GREENS CREEK MINE 2024 Reclamation Plan Approval Audit

December 2024

Hecla Greens Creek Mining Company

Figure 1. Tails Monthly Composite ABA

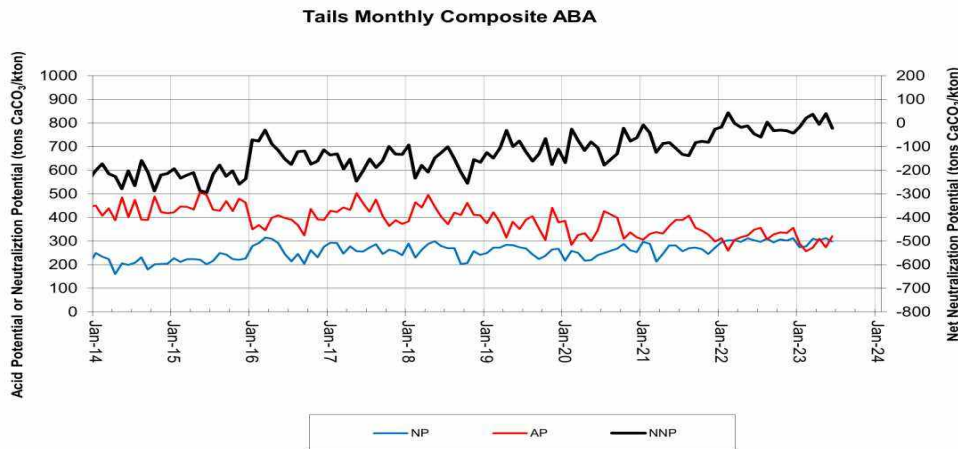
Tailings contain pyritic sulfur, which through weathering processes can lead to acid generation. However, the tailings also contain significant carbonate, which neutralizes the acid. Previous studies have shown that the lag time for acid generation from exposed tailings is on the order of decades. The prevention of acid generation from the TDF is one of the primary management objectives. As part of the TDF standard operating procedure (GPO Appendix 03, Attachment A), composite samples are collected from the tailings filter press monthly for Acid Base Accounting (ABA) analyses. Example analytical results for samples collected during the reporting period are shown in **Table 3**. Samples had an average acid potential of 316 tCaCO₃/kt, an average neutralization potential of 284 tCaCO₃/kt, and an average net neutralization potential (NNP) of -32 tCaCO₃/kt. Figure 1 graphs the results from tails monthly composite ABA samples collected since 2014. NNP has shown an upward trend over the past 10 years due to a decreasing trend in acid potential. (Hecla H2 2024 Biannual Report; HGCMC, 2024).

HGCMC appears to be following the GPO and RPA with regards to the TDF; the following recommendations are provided for consideration as part of the renewal of the RPA:
